23 MACKLIN STREET

PLANNING STATEMENT

EMAIL FROM NICK BAXTER OF CAMDEN COUNCIL DATED 11.09.13.

Macklin Street 23 pre-app

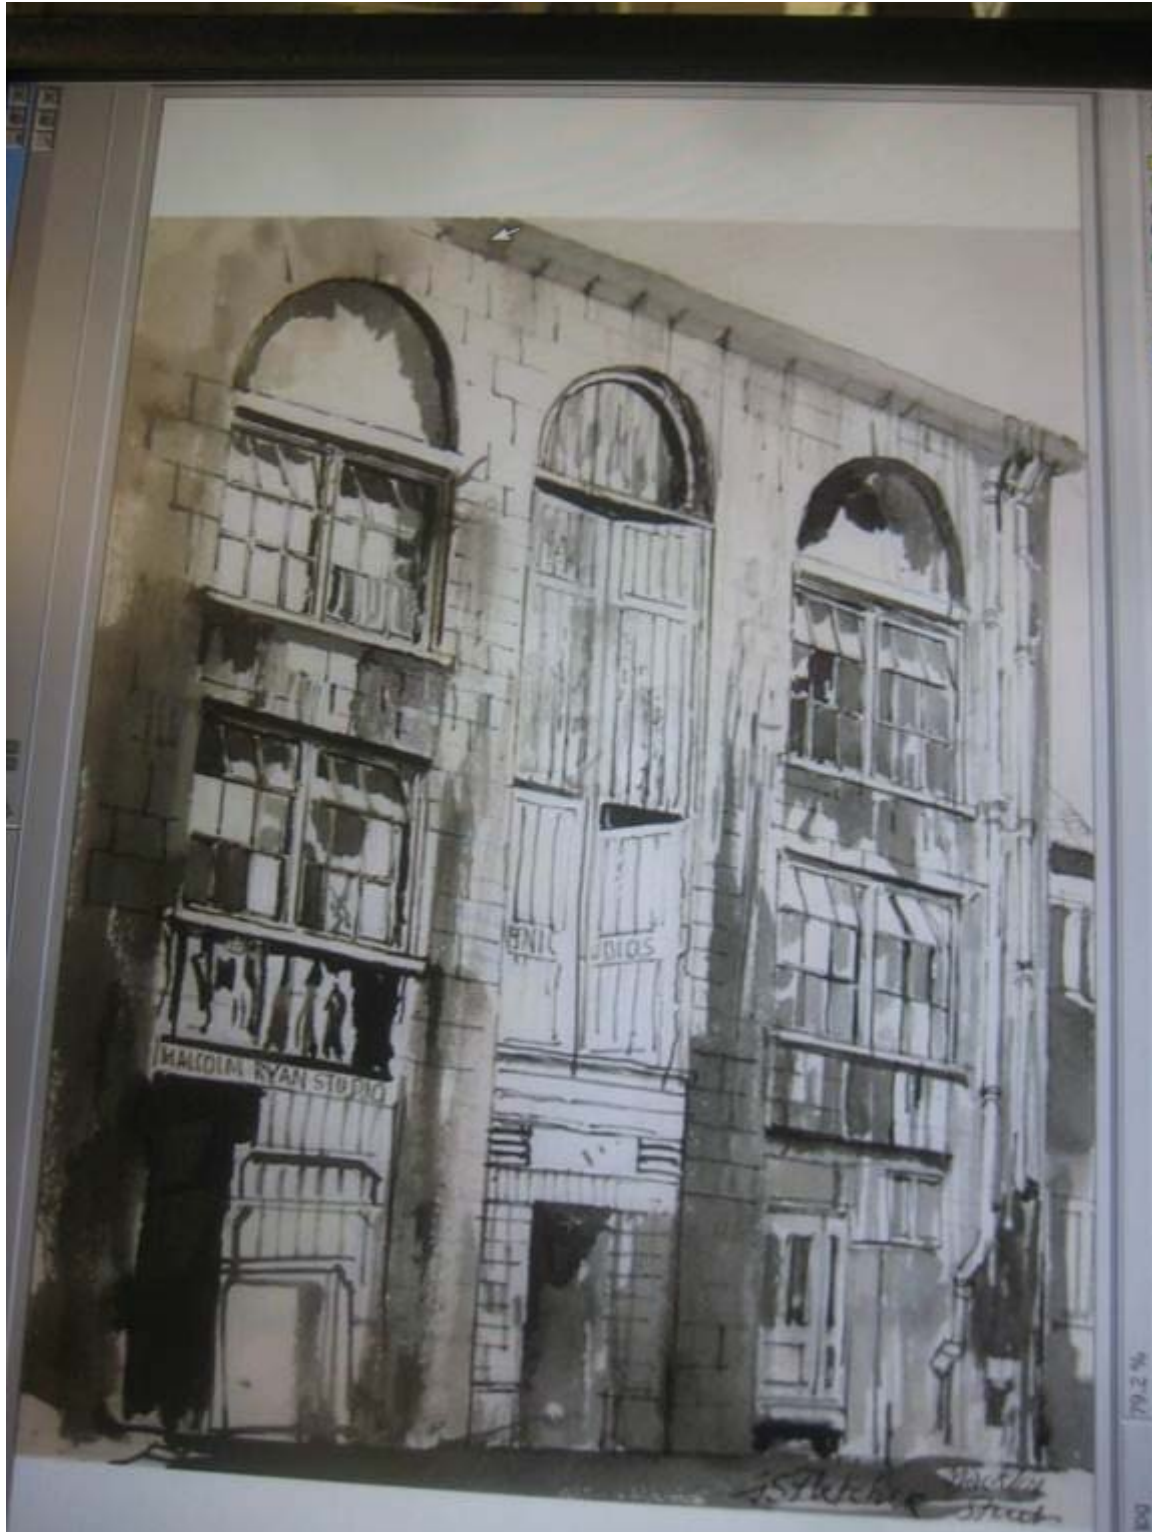
An important part of the special interest of the building is its lofty, industrial interior, composed of three-storey arches of intricately detailed brickwork, terminating at the apex of the roof. The interior expands as the entrance stair is climbed. More and more of the lofty space is unveiled as the modern, central island structure is passed on one's left. More detailed examination exposes the slots running around the floor on three sides, pulleys in the rafters and strangely arranged beams in the basement, which reveal the almost unique original use for which the building was constructed.

Around a third of the interior has already been given up to a full-height slab of residential accommodation to the south. The remaining set-up takes the form of a subservient modern box sitting respectfully within a grander historic box. This sensible and appropriate arrangement allows the maximum appreciation of the special interest of the building, while permitting domestic use.
